Aesthetic Analysis and Orderly Development Review

Industrial Tower and Wireless, LCC Telecommunication Facility

Town of Enosburgh, Franklin County, Vermont

Case Number 22-2120-PET

Figure 2.6-1 Photosimulation Evaluation for the Applicant's Viewpoint One from Vermont State Route 108

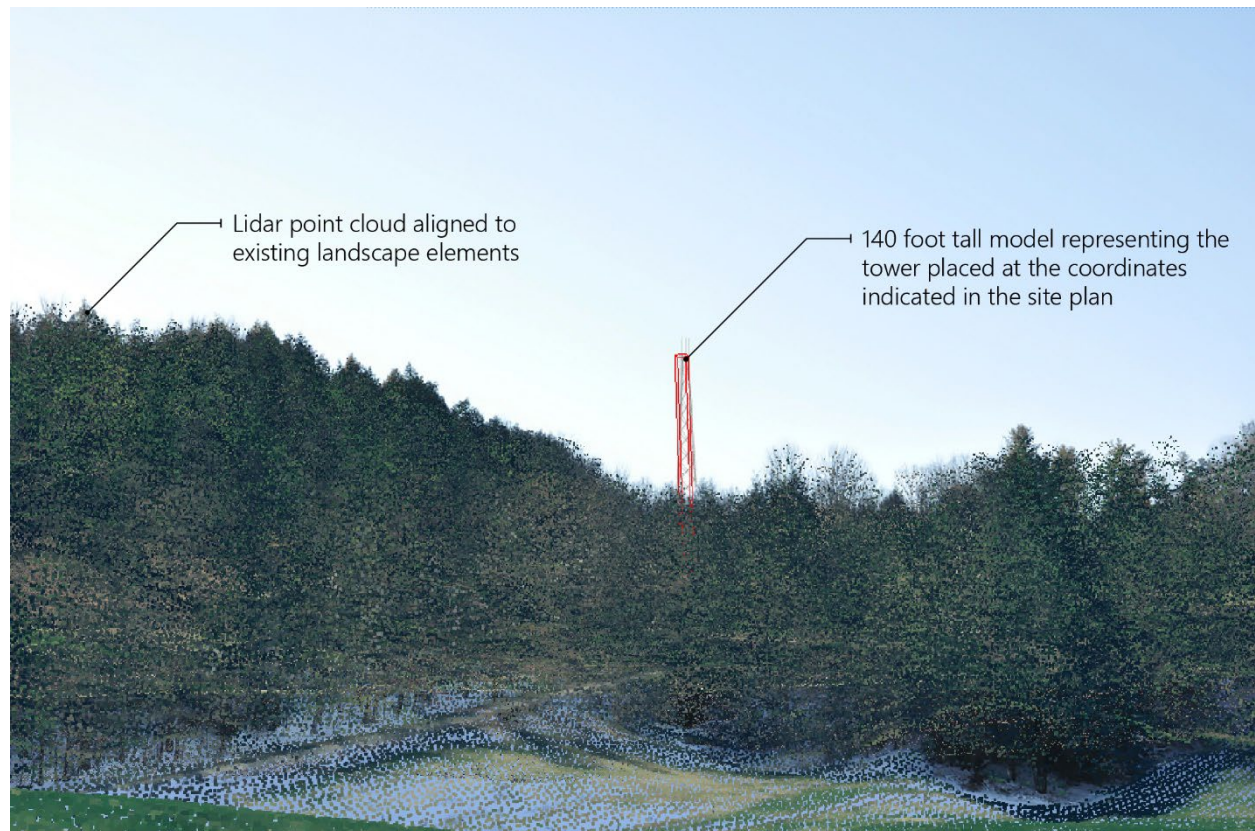
Based on EDR's review of photosimulations, the Applicant's photosimulations appear to be spatially accurate and provide a variety of viewing distances and geographic locations to adequately illustrate the range of visual change that will occur with the Facility in place. The photosimulations also appear to be a reasonably accurate representation of light reflection and color casting based on the time and date noted on each photosimulation sheet.

The greatest levels of visual contrast of the Facility with the existing landscape is represented by Viewpoint 1, where the majority of the tower is visible and viewed from a close distance in Rural Valley locations. In these viewing conditions, individual steel members of the tower are discernable to casual viewers and, due to the viewer's inferior position afforded by valley locations, will often be viewed against the sky. From these locations, the tower contrasts with existing elements of the landscape in terms of line, form, and scale. In this photosimulation, the back-lit tower results in a high degree of visual contrast when viewed against the sky. It is likely that in a side or front lit condition, this color contrast could be significantly reduced because galvanized steel is much brighter in color when presented in full sun. However, in rare cases, the side lit or front lit condition can result in reflective glare that has the potential to increase the contrast presented by the Facility. Due to its prominence, the tower could become the focal point in these views and present appreciable contrast with the existing visual environment. However, the photosimulations from Viewpoints 2 and 4, which are also from Rural Valley locations, demonstrate that the contrast associated with the Facility is greatly reduced when the majority of the tower is screened and/or it is viewed at greater distances. While the tower is clearly visible in Viewpoint 4, it no longer appears out of scale with the surrounding landscape, and the individual components of the tower are no longer discernable or compete for viewer attention with other landscape elements, such as the distribution and fence poles, that are visible in the view. At the distance the tower is viewed at in Viewpoint 2, it will be barely discernable to casual viewers.

Figure 5.2-1 Diagram of Above Ground Tower Height from Applicant's Viewpoint One from Vermont State Route 108

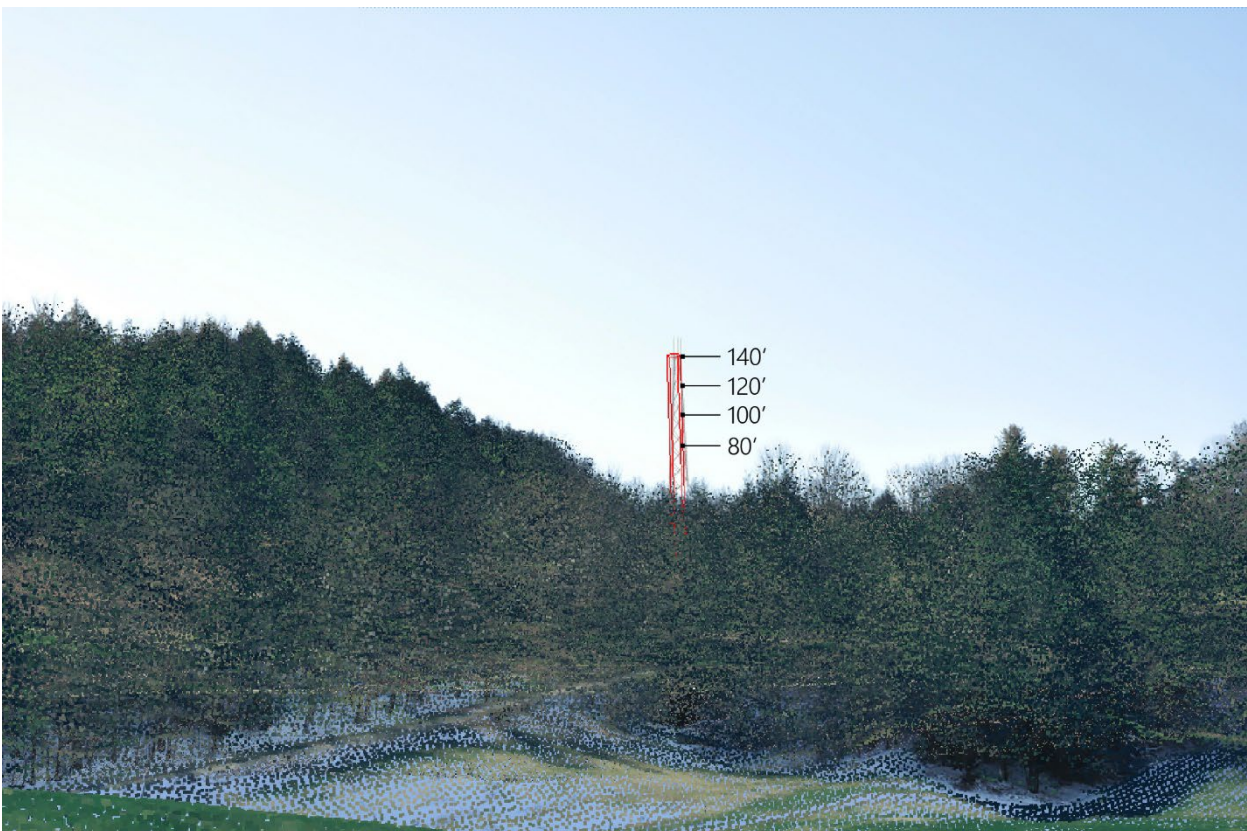
In addition to this viewshed analysis, 3D modeling software was used to determine the top of the tower that would result if incremental height decreases were implemented for the Applicant's photosimulation from Viewpoint 2. The results are shown in Figure 5.2-1. As indicated in this figure, unless the height of the tower was substantially reduced, these changes will not significantly alter the overall visual effect of the proposed tower from views in close proximity to the tower or within the broader landscape.

Figure 5.2-1 DSM Viewshed Analysis Results for 120 Foot Tall Tower

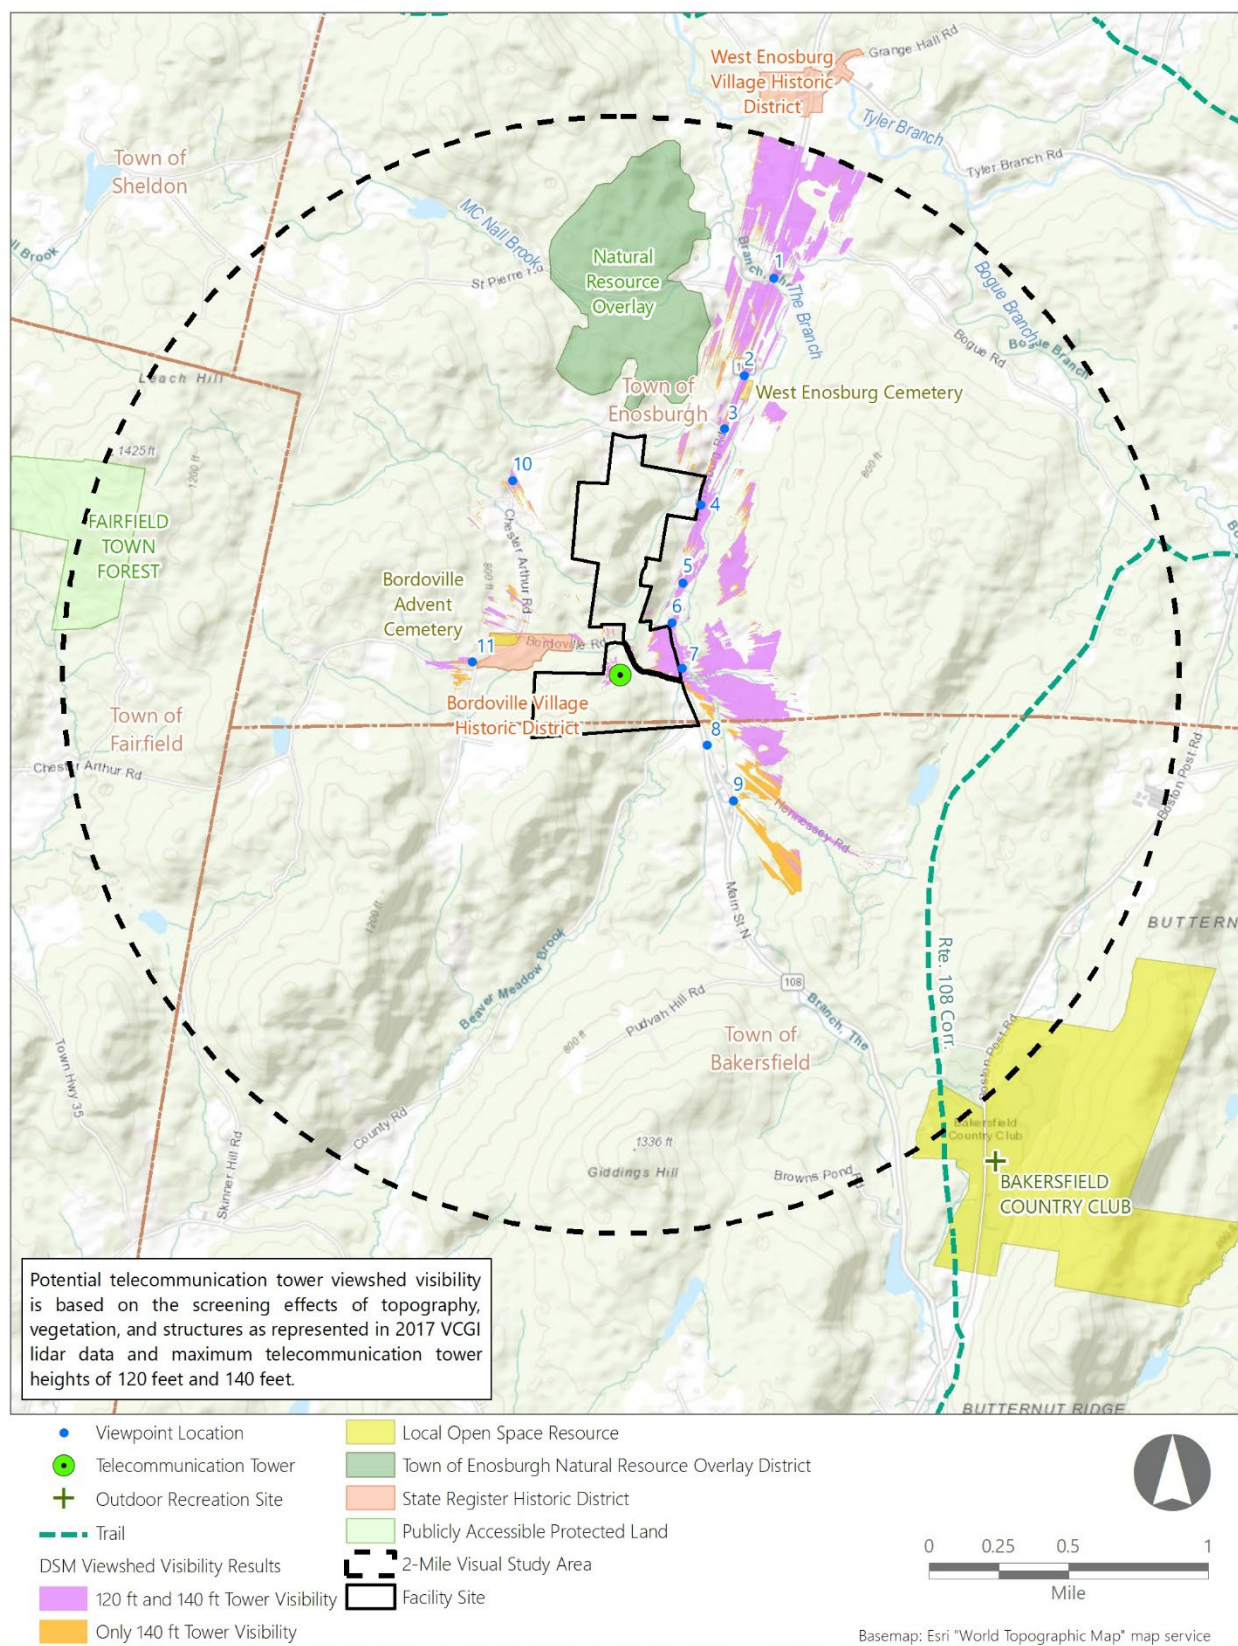
In order to provide additional information on whether a height reduction of the tower would result in a substantial reduction in Facility visibility, a DSM-based viewshed analysis was prepared using a tower height of 120 feet. Other data sources and parameters used in this viewshed analysis are as described in Section

2.4. The result of this viewshed analysis indicates that an 120-foot-tall tower could be visible from approximately 2.5% of the VSA (i.e., the tower would be entirely screened from 97.5% of the VSA). This indicates that the area within the VSA with potential visibility of the tower would decrease by 0.6% as a result of the height decrease. As shown in Figure 5.2-1, the 20-foot height decrease results in a small reduction to the geographic extent of project visibility. The area that would experience the greatest reduction in tower visibility occurs in agricultural fields southeast of the Facility near Hennessey Road. However, for most locations, the height reduction results in a small decrease in the size of previously visible areas, rather than entire geographic areas being removed from visibility.
